Cessna 177 Stabilator
Balance Weight Arm - Bracket

AWB 27-014 **Issue** : 1
Date : 17 August 2012

SEB89-1
Revision 3

STABILATOR BALANCE WEIGHT ARM BRACKET INSPECTION/REPLACEMENT

Figure 1. Stabilator Balance Weight Arm Brackets Inspection & Replacement (Sheet 1 of 4)

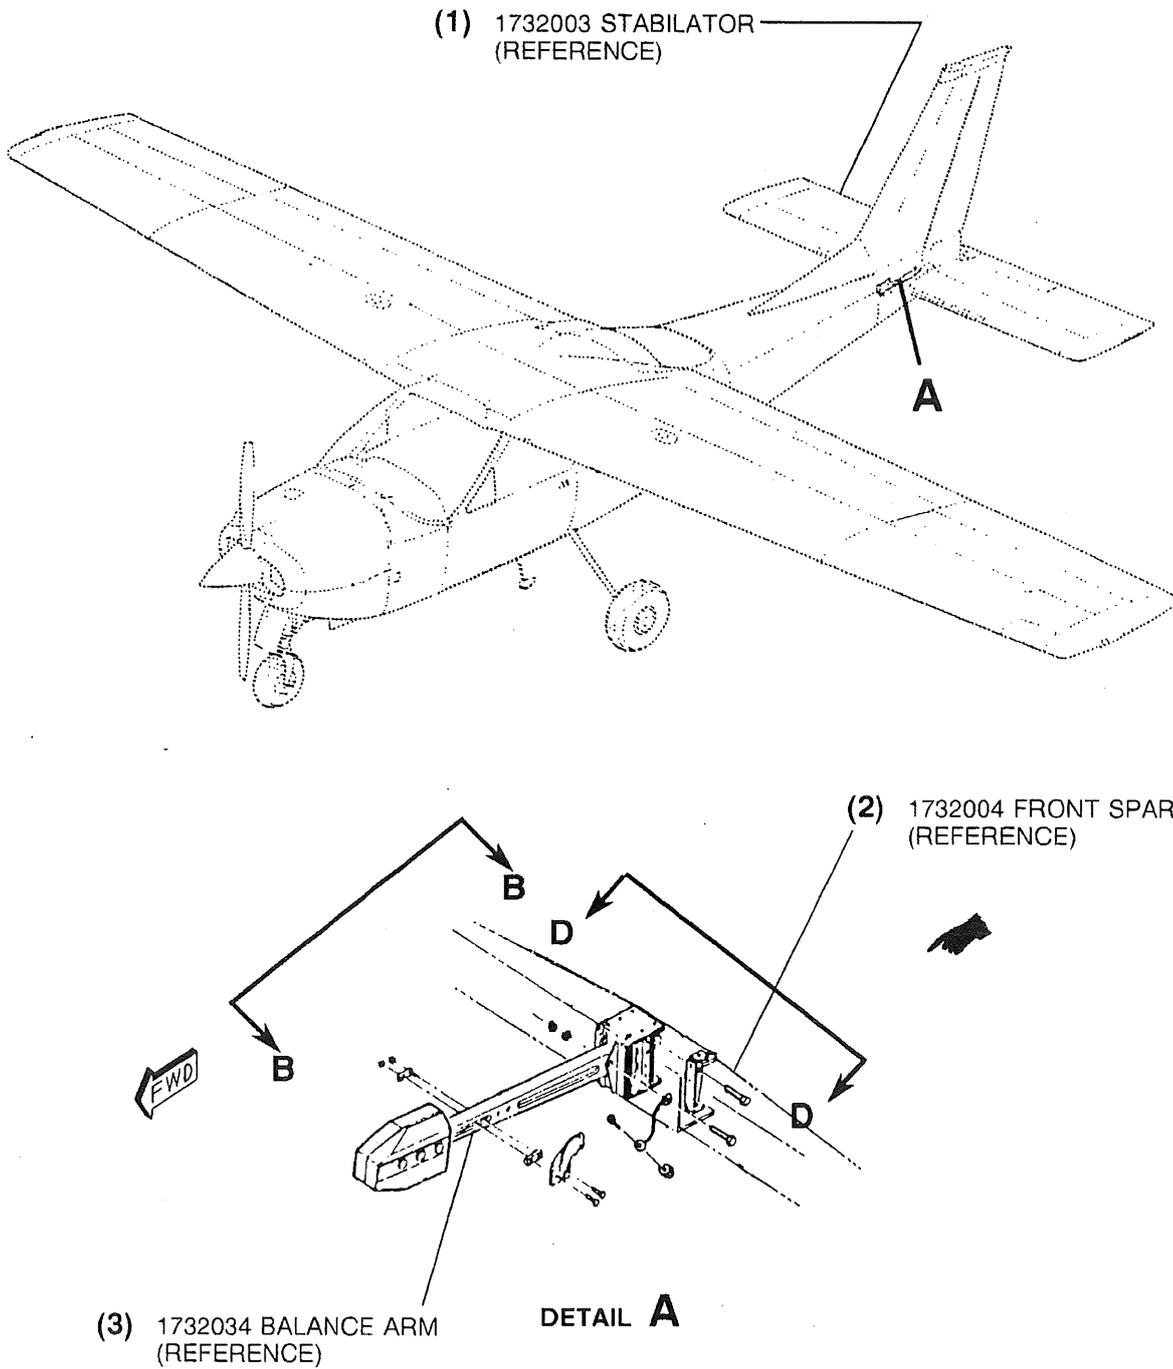
- A. Stabilator balance weight arm brackets inspection and replacement.
1. Remove stabilator (1) from airplane per appropriate Service Manual (refer to Figure 1, Sheet 1).

5. If a crack or cracks are detected, proceed as follows.
 6. (Refer to Figure 1, Detail A, View B-B, C-C & D-D, Sheets 1 thru 4) With the balance arm removed, drill out existing rivets in location (7 & 12) on both RH & LH brackets (5). Remove and discard brackets.

Figure 1. Stabilator Balance Weight Arm Brackets Inspection & Replacement (Sheet 2)

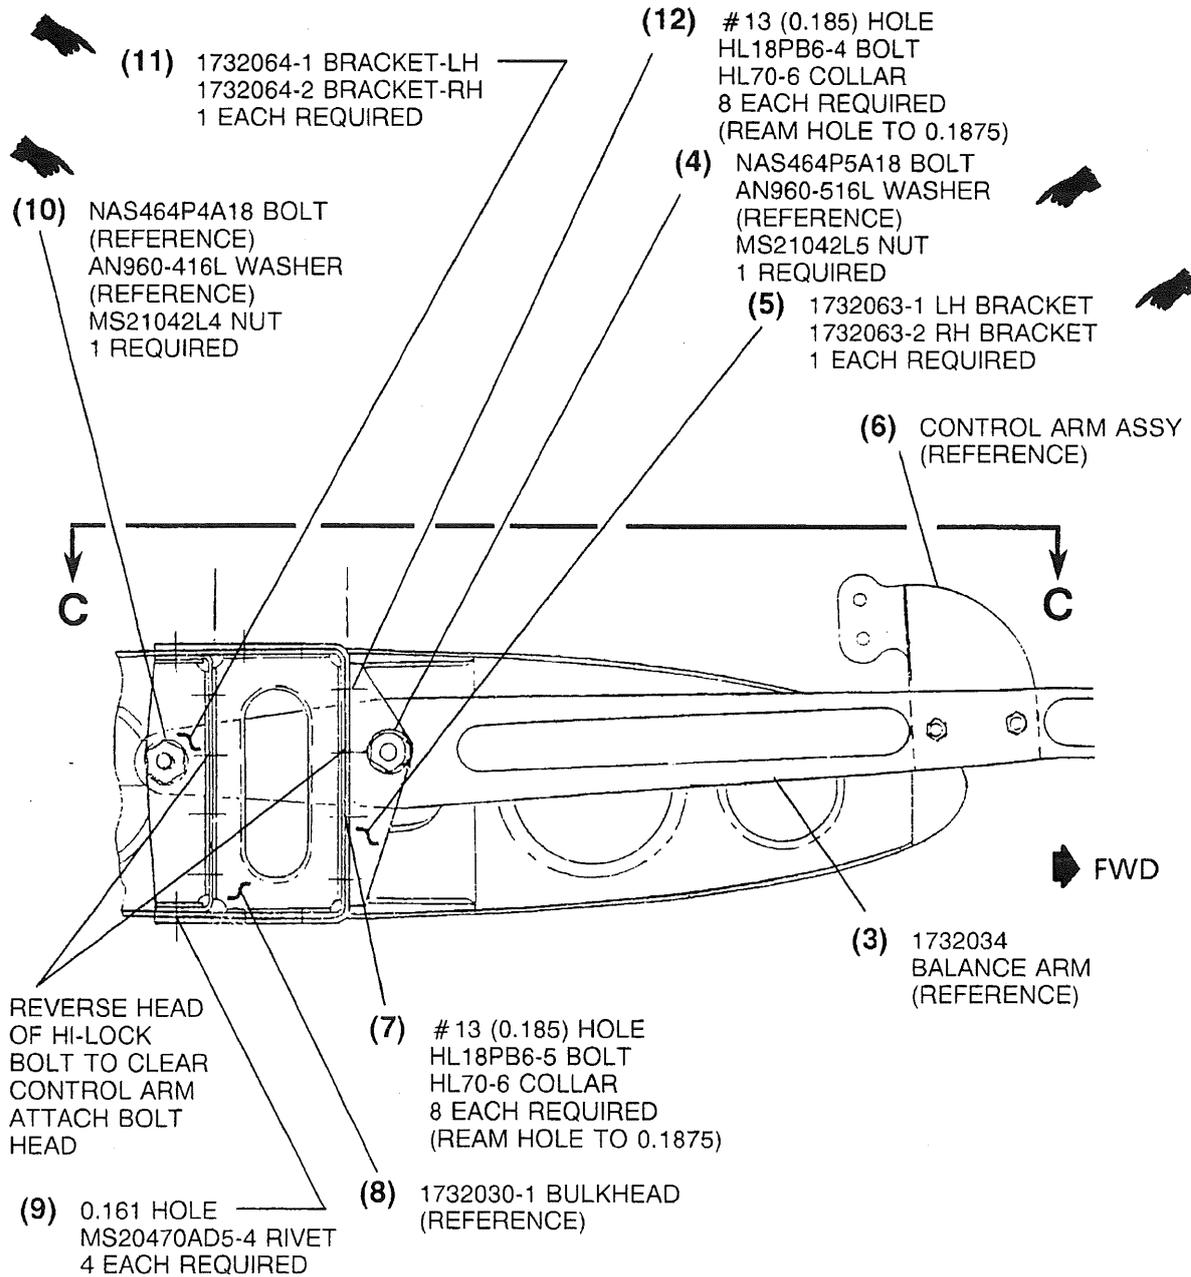
2. Remove balance arm (3) from stabilator by removing bolts, washers and nuts (4 & 10), retain balance arm, bolts and washers, discard nuts (refer to Figure 1, Sheets 2 & 3).

3. Visually inspect RH & LH brackets (5 & 11) for cracks, especially near the radius under the bolt hole. If no cracks are visible, use Eddy Current inspection to verify no small cracks have started.

Figure 1. Stabilator Balance Weight Arm Brackets Inspection & Replacement (Sheet 4)

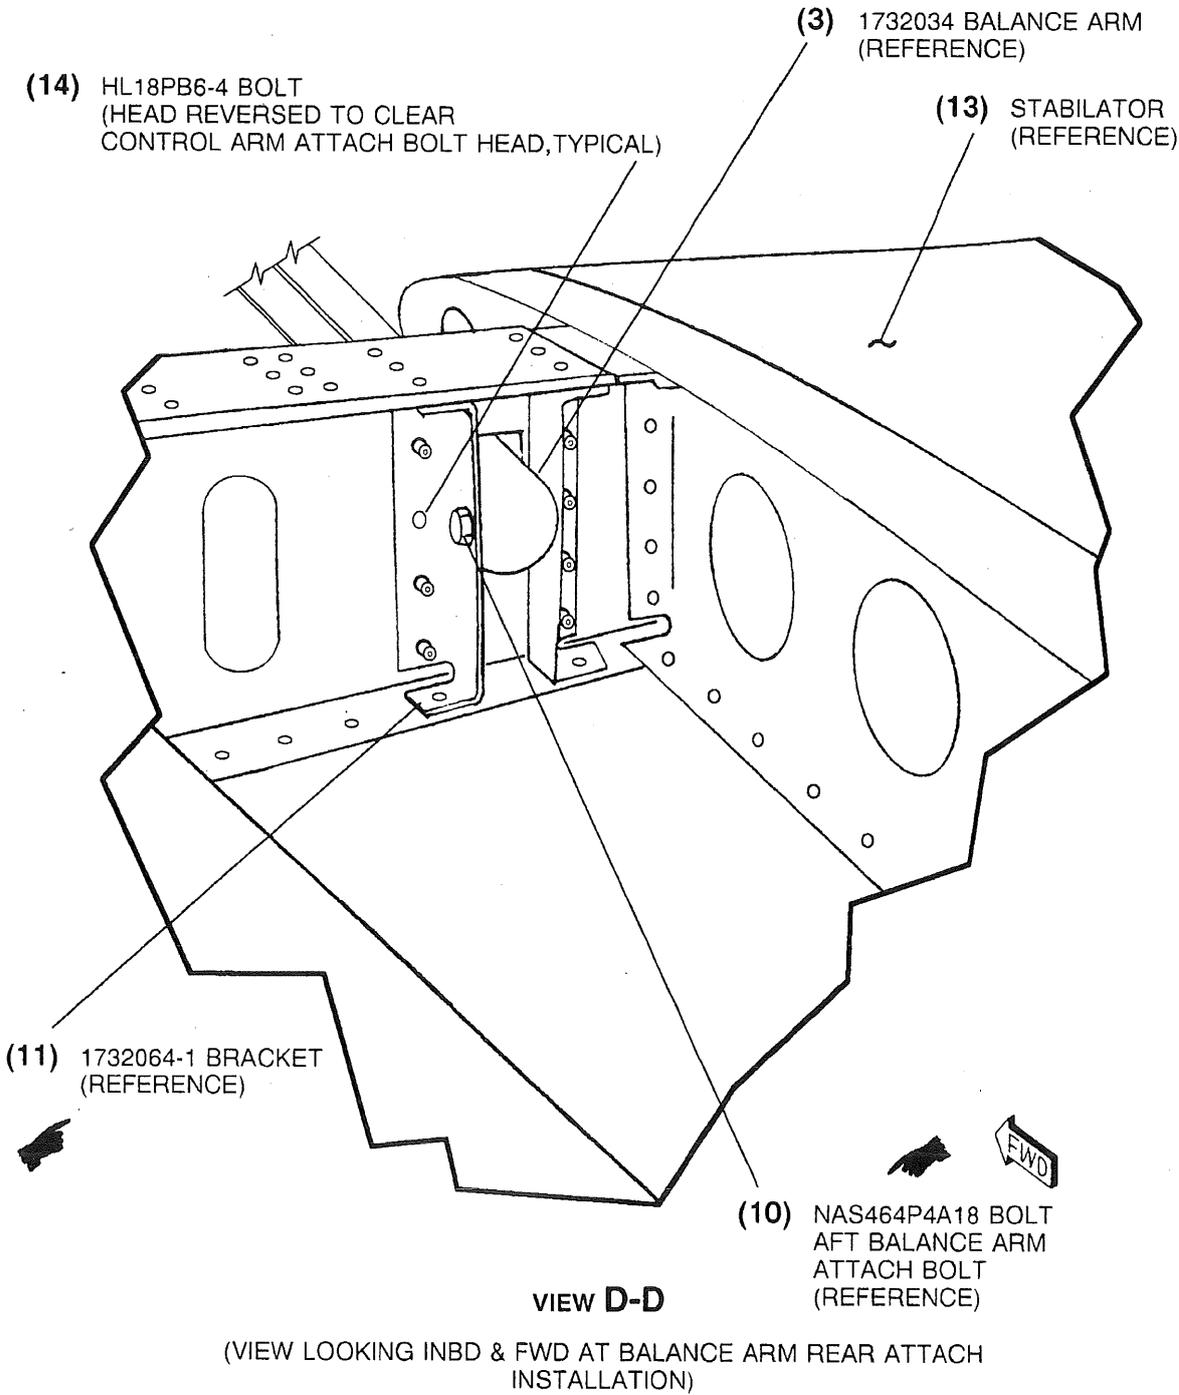
11. Deburr and clean holes reamed in Step 10.
 12. Secure brackets (11) using rivets (9) and Hi-Lock bolts and collars (12). Reverse Hi-Lock bolt head (14) as shown in View D-D, Sheet 4, to clear control arm attach bolt head (10).
